TOWN OF PLYMOUTH
Department of Public Works
Engineering Division
26 Court Street
Plymouth, Massachusetts 02360

MEMO

Ref: LWP Plymouth, LLC– Case No 3970
Colony Place
Parcel ID 104-000-026-029

**RE: The Walk at Colony Place Development, Plymouth, Massachusetts
Supplemental Water System Analyses**

Figure 1: Northern Zone Firm Capacity

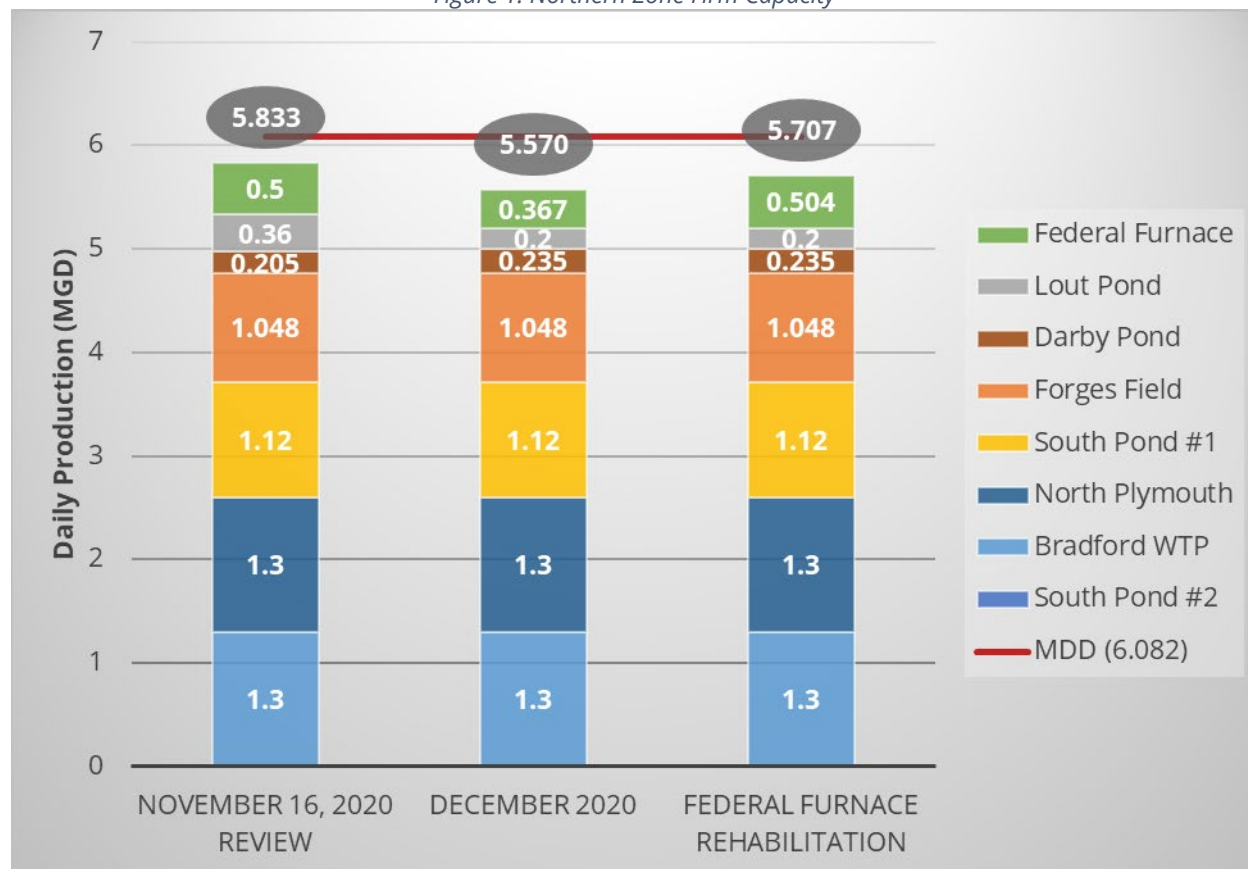
Based on a review of the information presented in Figure 1, the northern pressure zones do not have the firm capacity to meet maximum-day demands.

EP Response 12/28/2020: As depicted in Figure 1 above, the firm capacity calculations incorporate the supply from Forges Field Well and continue to show a deficit when compared to the maximum day demand.

Figure 2: Monthly System Demands & Northern Zone Firm Capacity

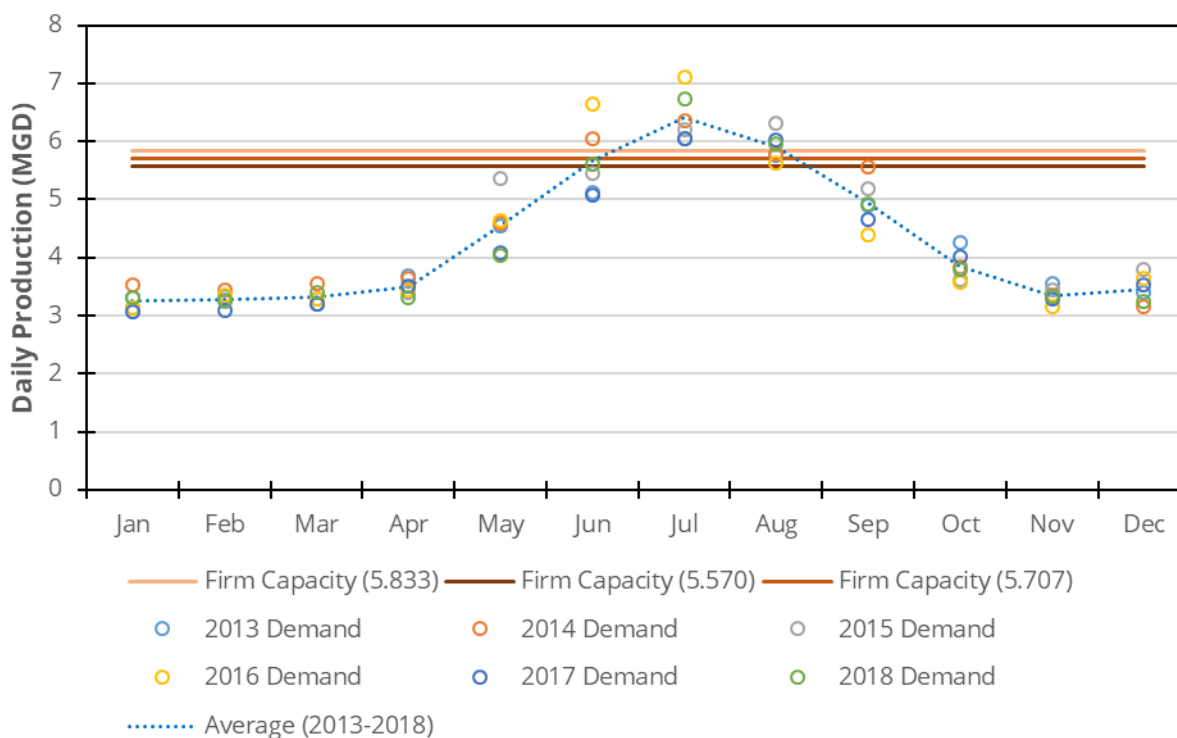
While demands are relatively low for most of the year, average monthly system demands often exceed approximately 6 MGD in June, July, and August. Since Darby Pond restrictions often go into effect in the late summer as discussed above, August and early September are the times of year when the water system is most at risk of a supply shortfall.

We also note that the Town has observed the potential effects of implementing a water ban on system demands during a drought. As illustrated in Figure 2, June and July 2016 demands were higher than other recent years prior to the implementation of a water ban. After implementing a strict water ban, the Town observed below average water demands in the subsequent months. Water bans are unpopular, and it can be difficult to predict exact reductions in demands. However, if the Town is willing to implement water bans and can achieve a similar level of demand reduction in a future water ban, it may be possible to overcome short-term summertime supply issues.

Figure 3: Northern Zone Supply Capacity during Loss of Supply Scenarios

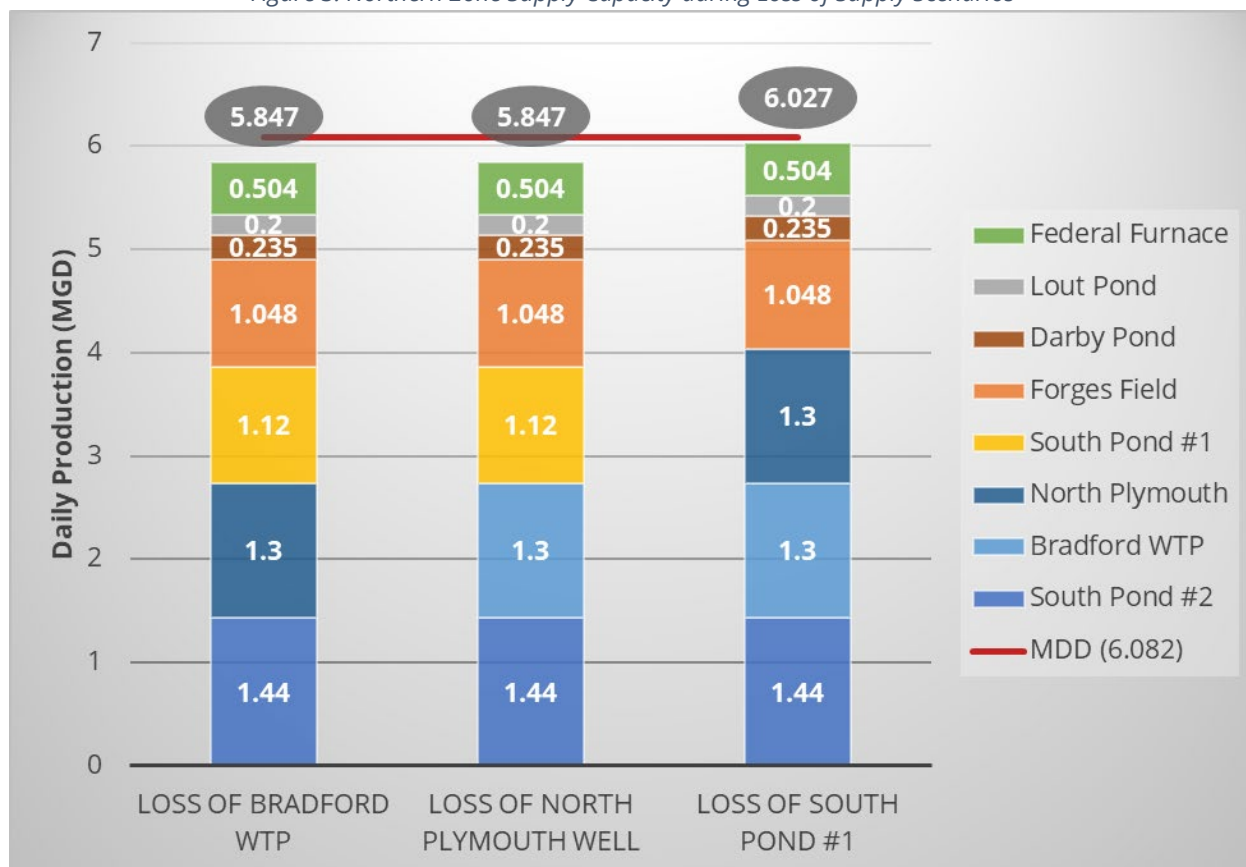
EP Response 12/28/2020: As discussed in the Firm Capacity section above, the firm capacity calculation is standard practice for a water utility. Regardless, the problem is more acute than simply the loss of the largest source, South Pond Well #2. In fact, as illustrated in Figure 3 below, the loss of any one of the Town's next three largest sources (Bradford Water Treatment Plant, North Plymouth Well, or South Pond Well #1) would result in a water supply deficit. Furthermore, if the Federal Furnace Well pump upgrades are not as successful as hoped, it is possible that the loss of Forges Field Well could also lead to a supply deficit.
